ATTACHMENT A

Responses to NRC Questions on Pilgrim I Reload 2
Licensing Submittal (NEDO-20855-01)

ATTACHMENT B

Responses to NRC Questions on Pilgrim
Single Loop Operation (NEDO-20999)

Figure 3-1 P101 40030001 PILGRIM 1990647/FULL CORE FLOW, LOSS OF 100 DEGREE F FH HEATER.

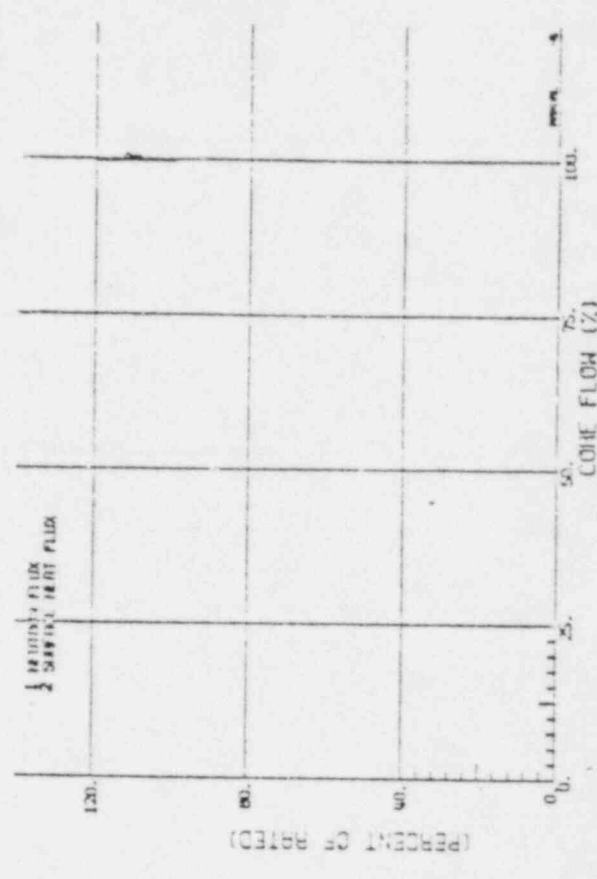
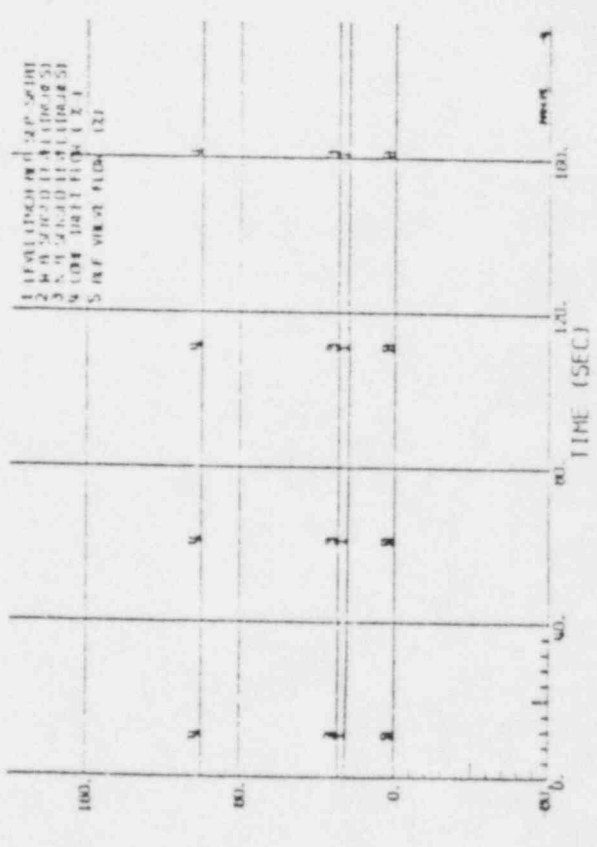
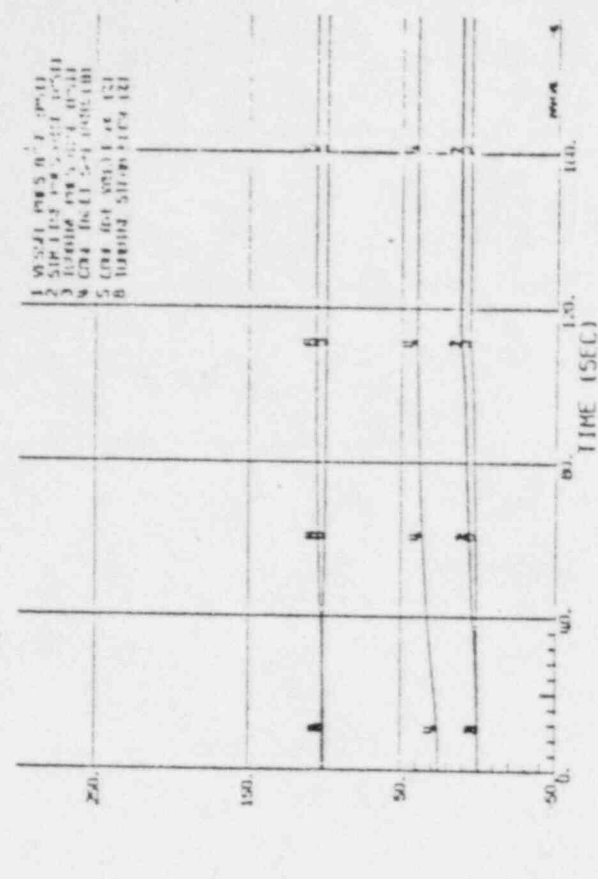
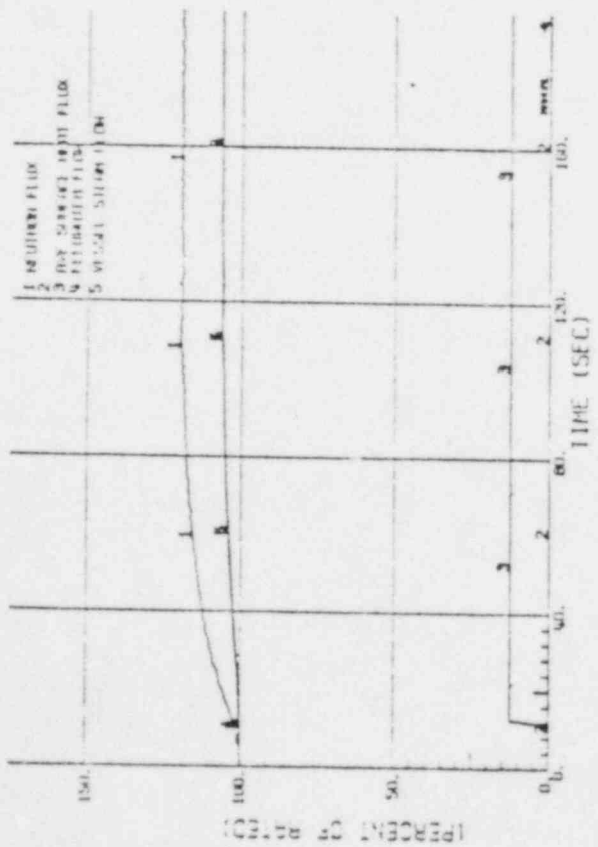
Question A3: Does a reactor scram occur as the result of a feedwater transient?

Response: In Paragraph 7.3.3.1.6.1 (Page 7-18) of NEDO-20855-01, the peak neutron flux was incorrectly stated as 120% of initial. The corrected statement should be: "Neutron flux increases to a value of 119.8% of initial at 109 seconds." Since the indicated neutron flux does not exceed the scram setpoint of 120%, scram does not occur. A time plot of the transient is shown in Figure 3-1 (attached).

Figure 5-1. Pilgrim Unit 1 Cycle 3, Power/Flow Map with Derated Boundaries

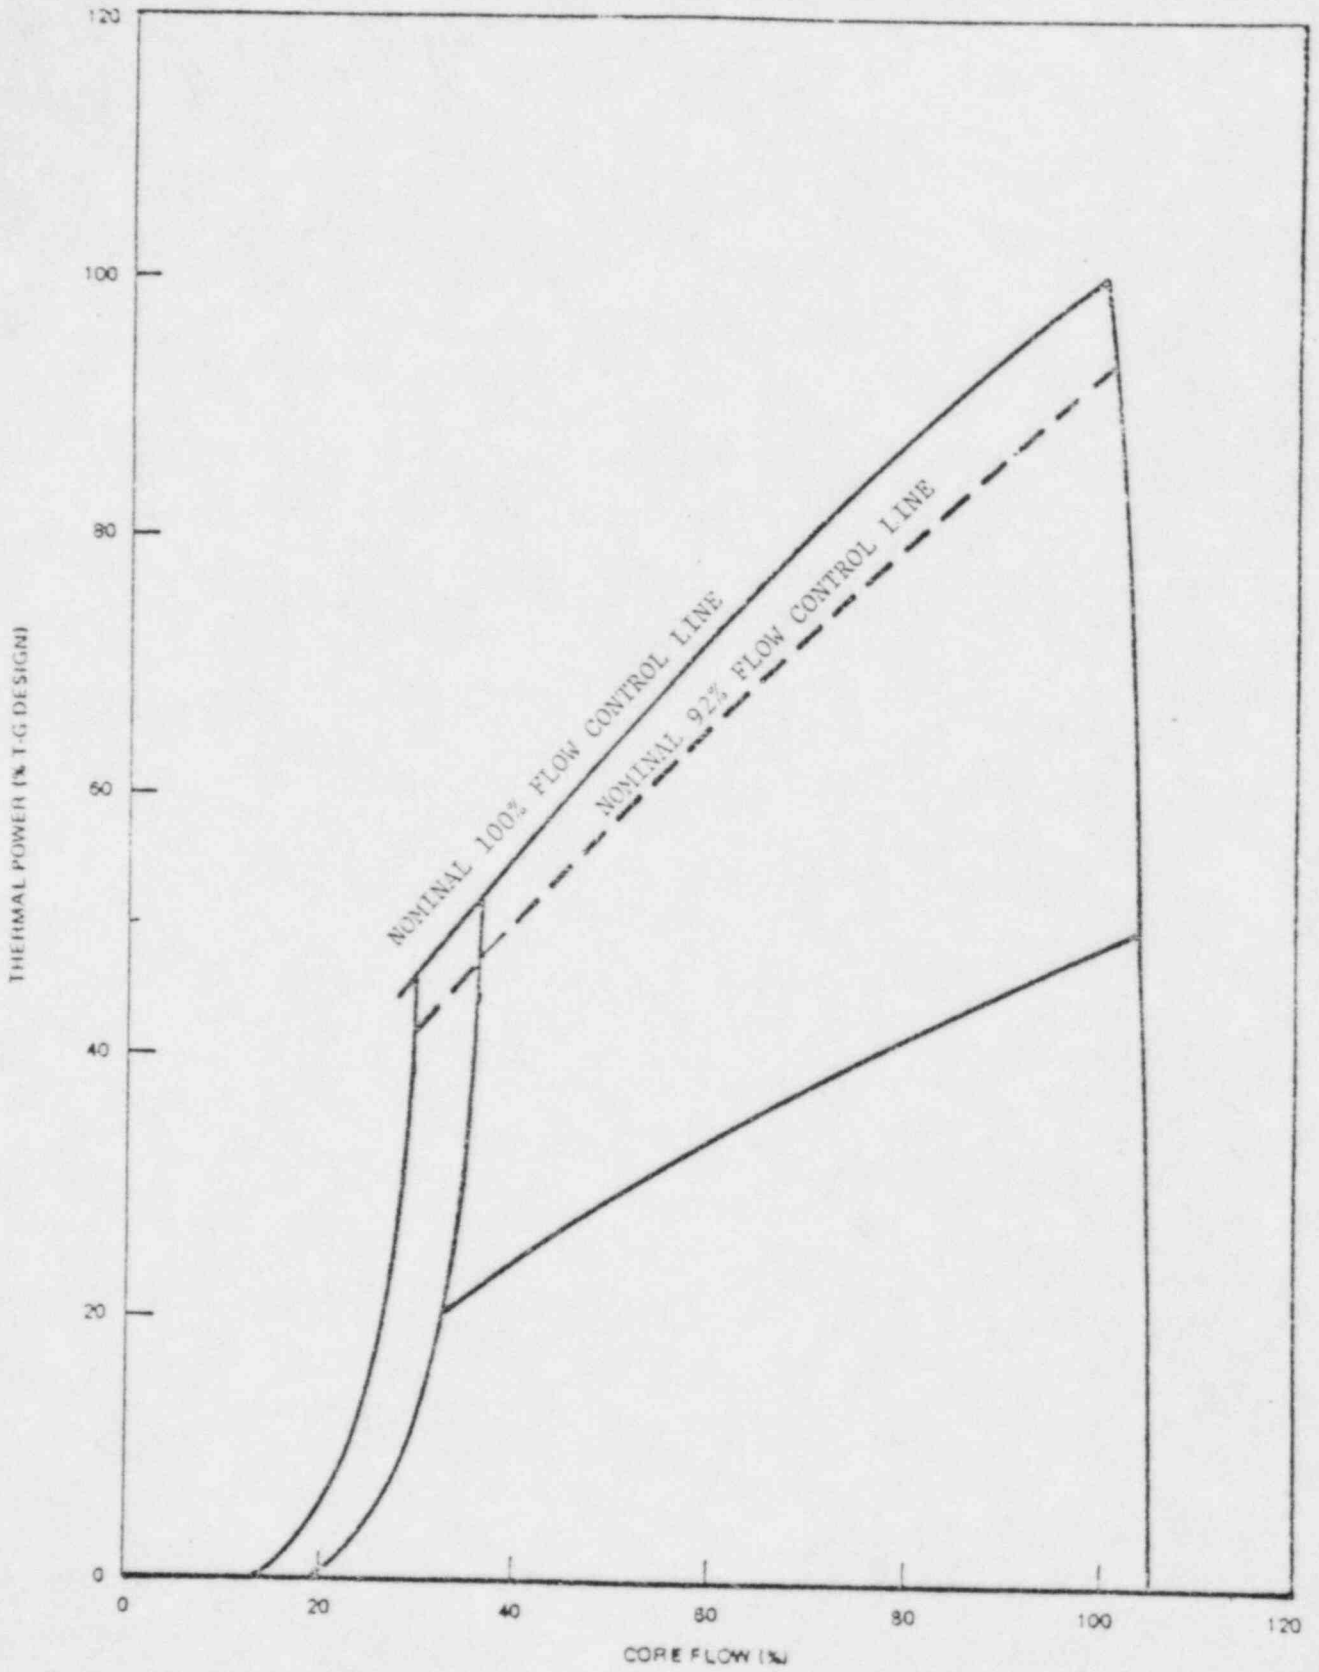
Question A4: Provide a power-flow map for Reload 2 showing a 92% power limit.

Response: The Pilgrim Cycle 3 power/flow map with the nominal 92% flow control line is shown in Figure 5-1, attached. Refer to response to Question A10 for a description of how Pilgrim 1 will operate on the power/flow map to achieve the 92% power, 100% flow endpoint at EOC-3.

FIGURE 4-1
 PEAK CLADDING TEMPERATURE FOLLOWING A
 DBA FROM SINGLE LOOP OPERATION FOR EXAMPLE
 PLANT

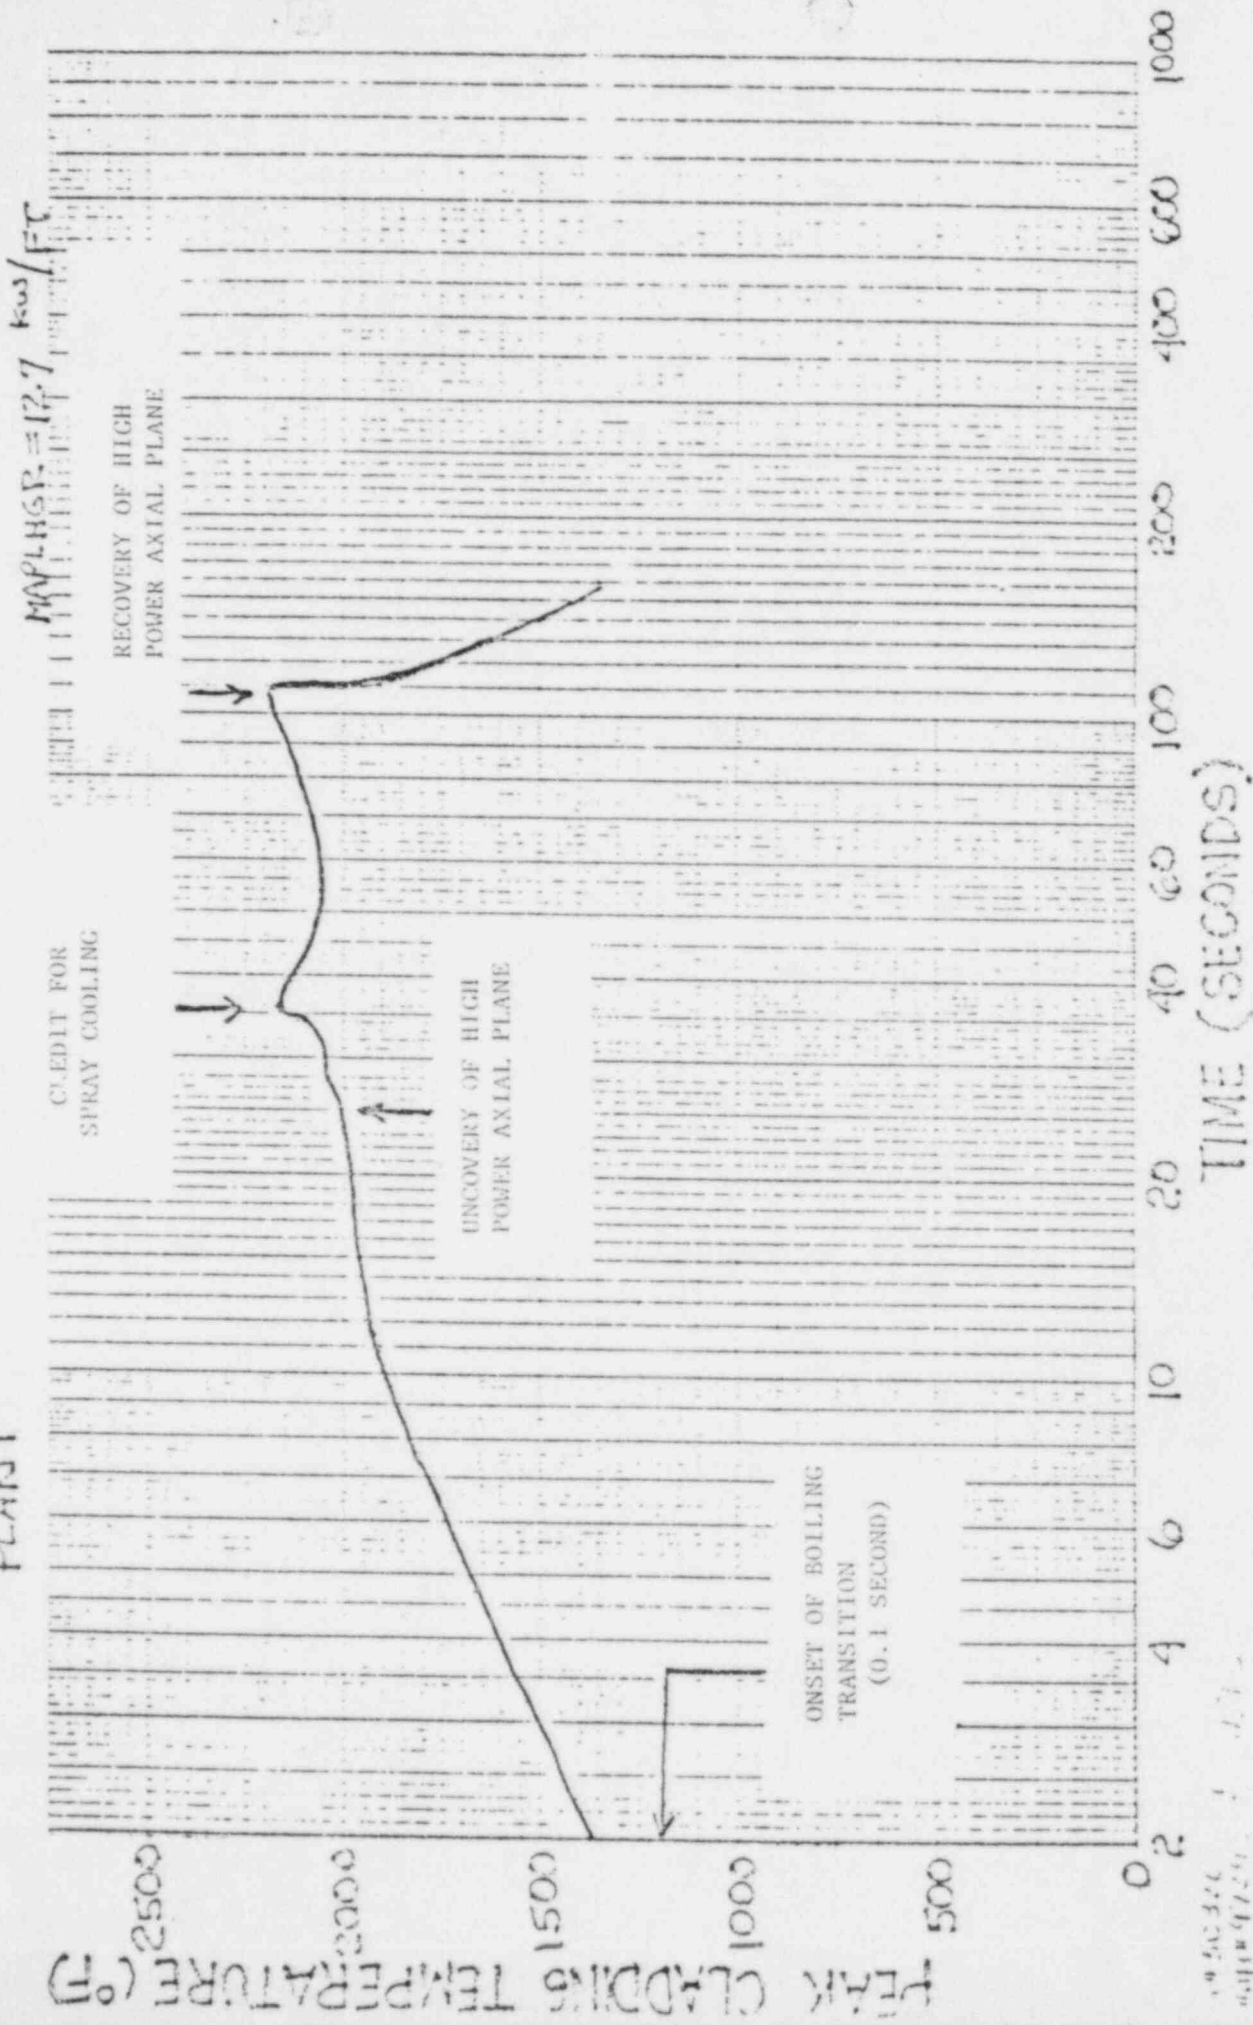
Question B4: Provide a curve of transient PCT of the lowest axial plain to experience CPR = 1.0 prior to jet pump uncoverly versus time with one pump operation.

Response: The cladding heatup analysis of the LOCA from one pump operation assumes that boiling transition occurs over the entire length of the fuel bundle at 0.1 seconds after the LOCA. In other words, all axial planes are assumed to experience CPR = 1.0 prior to jet pump uncoverly. Therefore, the high-power axial plane experiences the most severe cladding heatup. Plots of calculated peak cladding temperature versus time for the high-power axial plane are provided in Figures 4-1 and 4-2 for early and late reflooding BWR/4 plants.
